**DEFENSE NUCLEAR FACILITIES
SAFETY BOARD**

July 26, 2022

Staff Report

Savannah River Site 296-H Tritium Stack Structural Review

Figure 2. Example Cross-sections for Vertical and Horizontal (“confining”) Reinforcement
(a) Single Layer of Reinforcement (b) Two Layers of Reinforcement (“two face”)
[Note: These are not cross-sections of the 296-H stack]

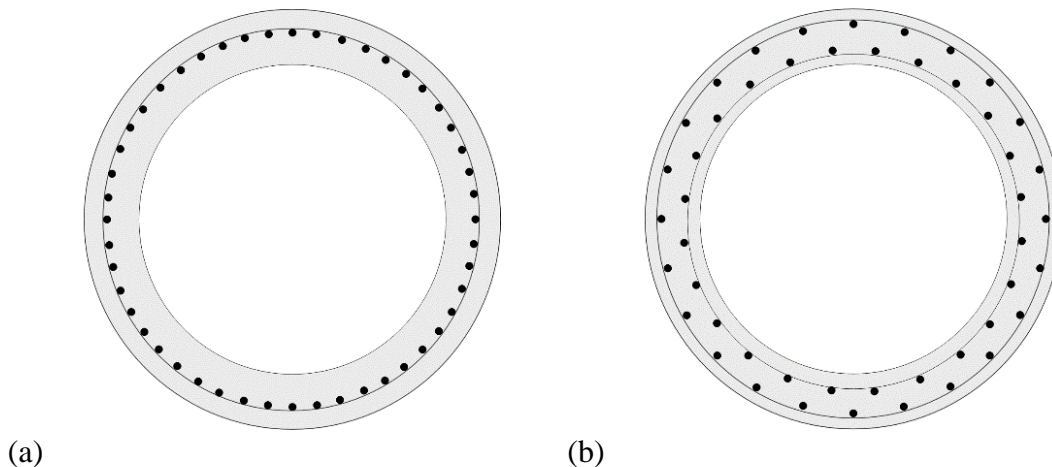
Single Reinforcement Design—Due to the vintage of the 296-H stack, it was designed with dated practices. In particular, the stack only contains one layer of vertical reinforcing steel along its length and only one layer of circumferential (confining) reinforcing steel in the horizontal direction. Figure 2 compares a single reinforcement configuration with a two-layer (“two-face”) reinforcement configuration. American Concrete Institute Standard 307-08, *Code Requirements for Reinforced Concrete Chimneys* [10], states the following in its commentary Section R4.1 (emphasis added):

*For the 1995 edition, the Committee re-evaluated the previous exemptions regarding two-face reinforcement and minimum wall thickness for chimneys 300 ft or less in height and less than 20 ft in diameter. Recent information has indicated that two-face circumferential reinforcement is necessary to **minimize vertical cracking** due to radial wind pressures and reverse thermal gradients due to the effects of solar heating.... [T]he current committee believes that two-face reinforcement should be required in all chimney columns, regardless of size, considering the **aggressive environment surrounding chimneys**.*

Since SRNS does not inspect the interior of the 296-H stack, the presence of vertical cracks within the stack has not been determined. It is SRNS’s position that there are likely no

interior vertical cracks since they would propagate through the thickness of the stack and be seen on the exterior of the stack. However, the Board's staff notes that interior vertical cracks may not manifest themselves on the exterior of the stack due to the presence of confining steel surrounding the vertical reinforcement.
